GEOCRES No. 3165-185DIST. 9 REGION W.P. No. 146-74-03BCONT. No. W. O. No. 92-11015STR. SITE No. HWY. No. 416LOCATION Diaphragm Walls Adjacent
to Lynwood SubdivisionNo of PAGES - Nepean

Re: Additional Foundation Investigation to
Determine Limits of Diaphragm Walls
Highway 416 Cut Adjacent to Lynwood
Village Subdivision, W.P. 146-74-03B
Nepean, Ontario

RE: **LIMITS OF DIAPHRAGM WALLS**
HIGHWAY 416 CUT ADJACENT TO LYNWOOD VILLAGE SUBDIVISION
NEPEAN, ONTARIO

Re: Black River Bridge
MTO Site 47-72
Design Review Meeting
December 14, 1992

Scale 1:1,000

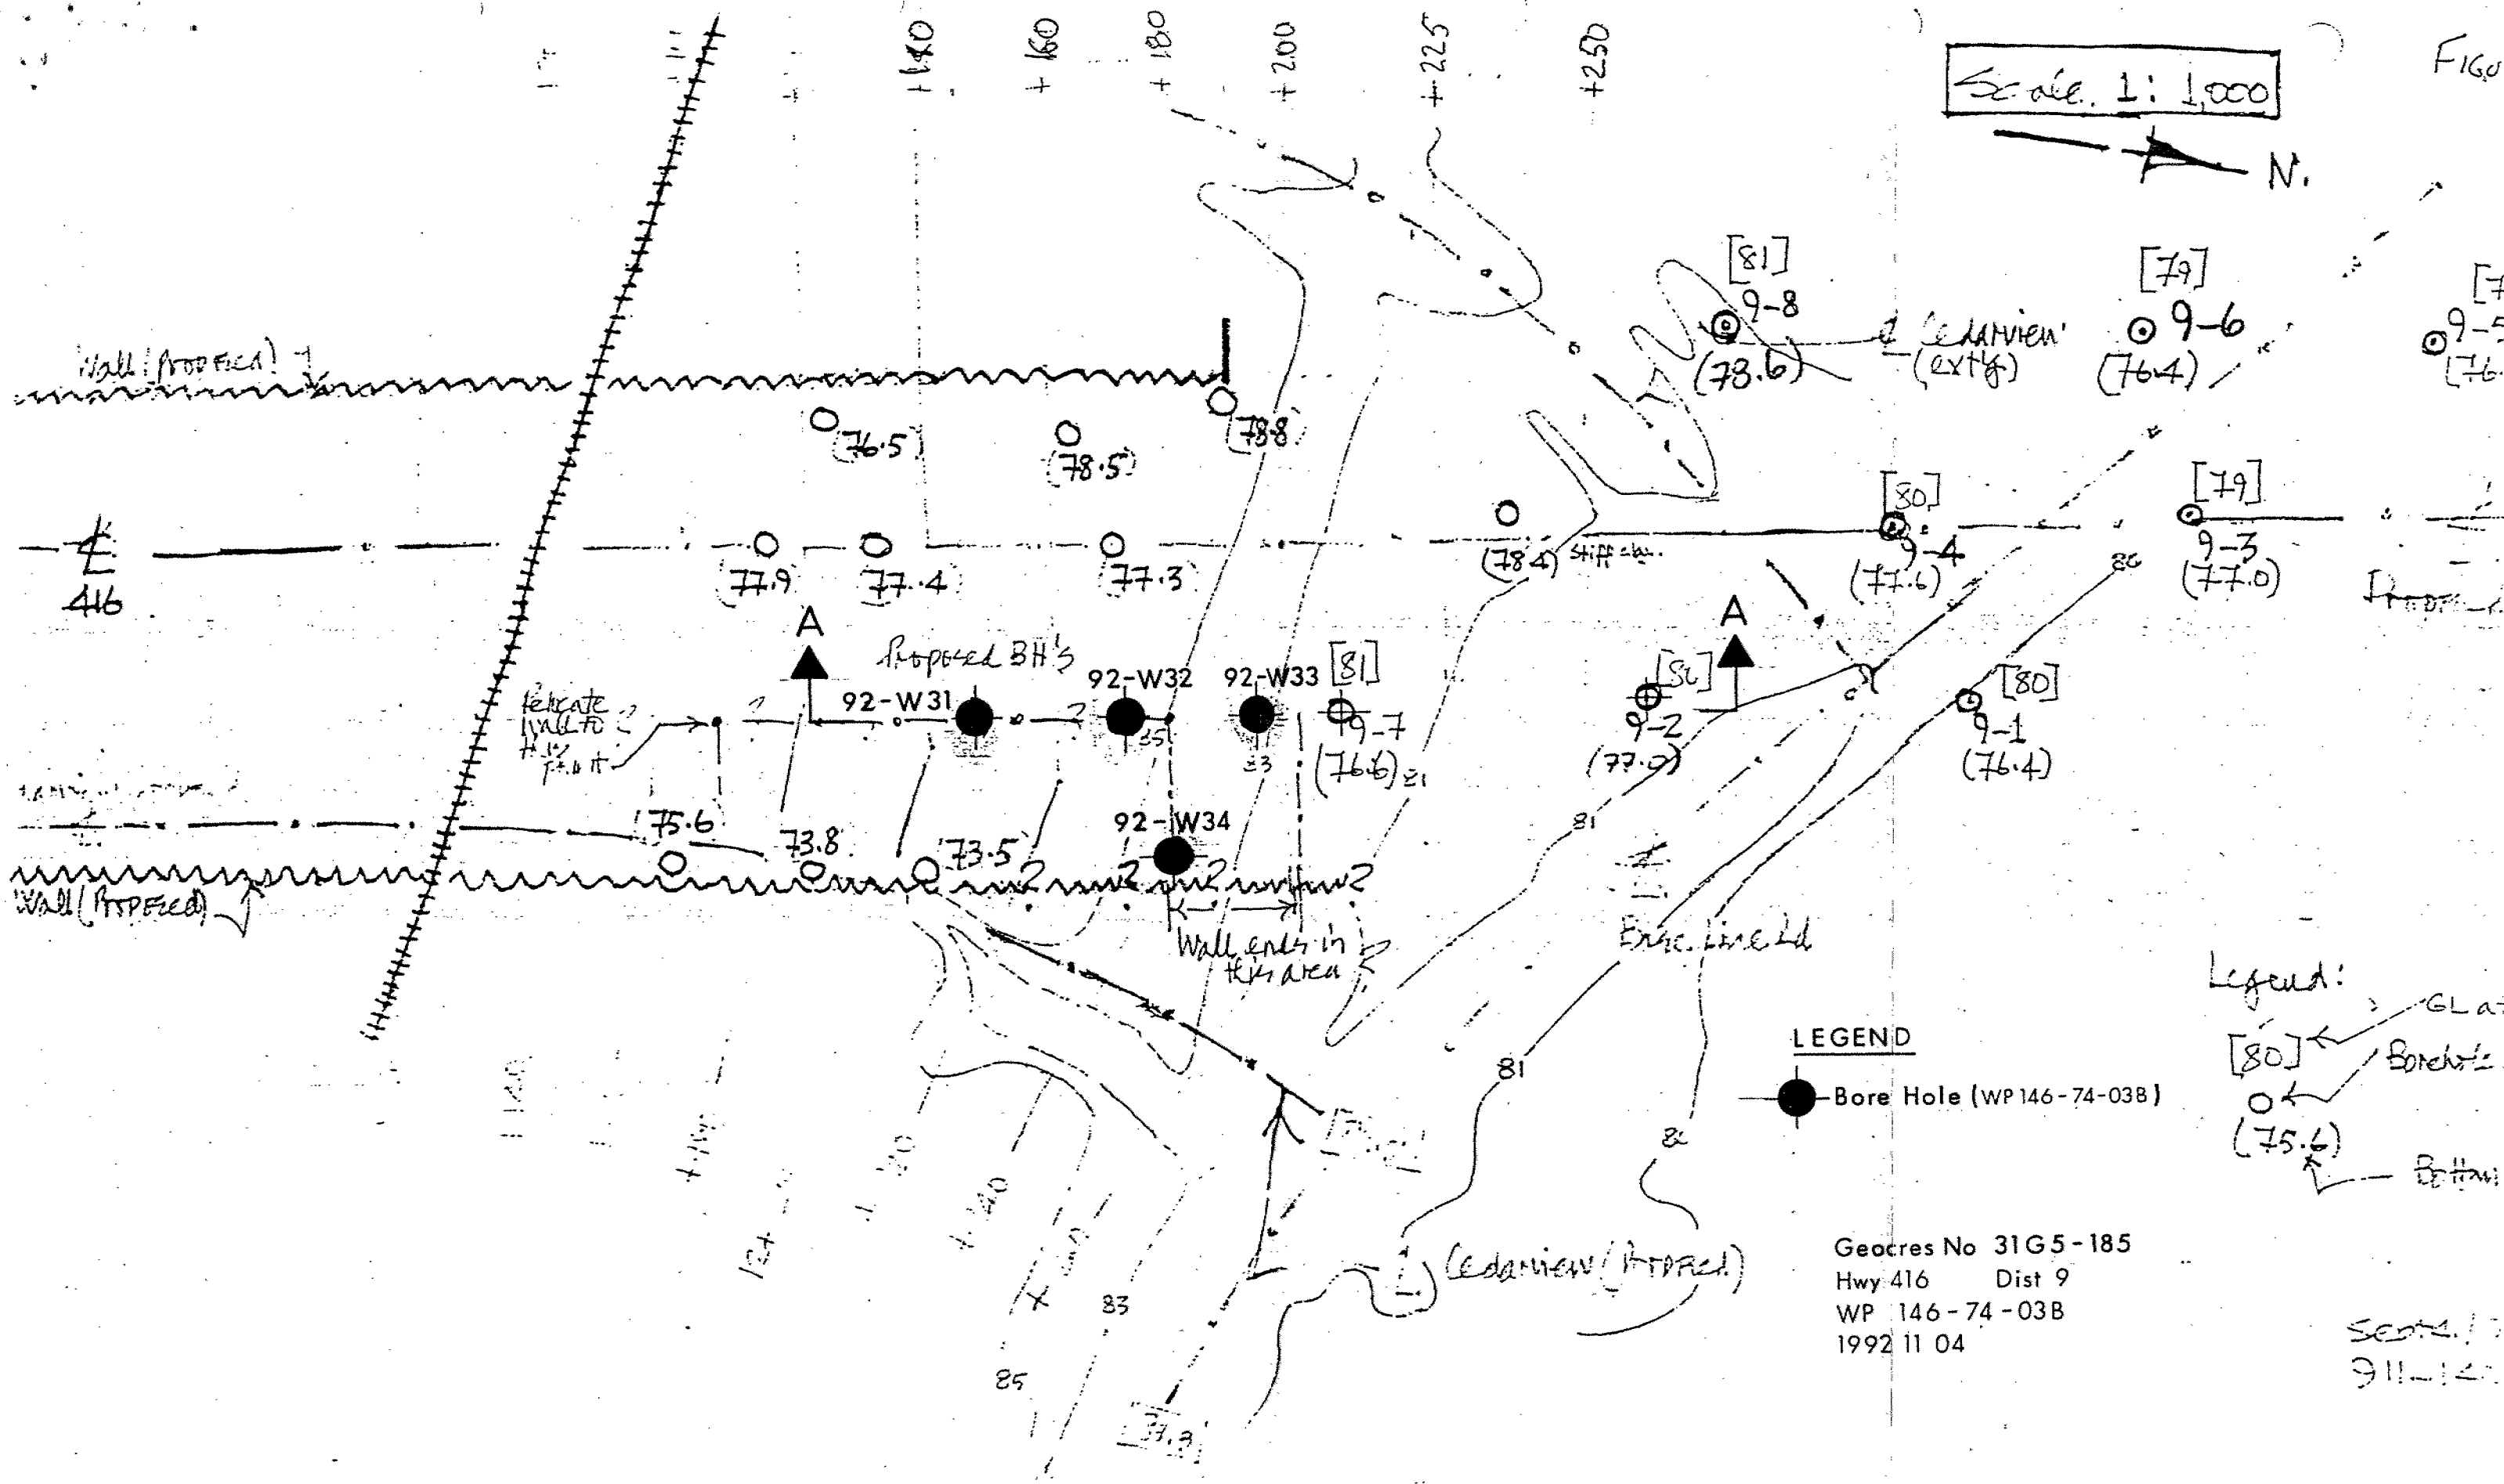
The results of the recent investigation reveals that the thickness of the surficial silty clay to clayey silt ranges from 9.1 m to 7.6 m. However, beyond borehole 92-W33, the thickness of the cohesive stratum decreases to a thickness of 3 metres (see BH 9-2, Section A-A). The stratum has a surficial crust of very stiff consistency approximately 3 to 3.5 metres in thickness underlain by cohesive material of firm to stiff consistency. It was evident that the samples of the underlying weaker material contained large natural moisture contents. In situ sensitivity values ranged from 5 to 10 indicating a sensitive to extra sensitive material. The cohesive stratum is underlain by a cohesionless heterogeneous mixture of silt, sand and gravel. This deposit of glacial till origin extends to the bedrock surface and has a thickness of 1.1 m to 2.7 m.
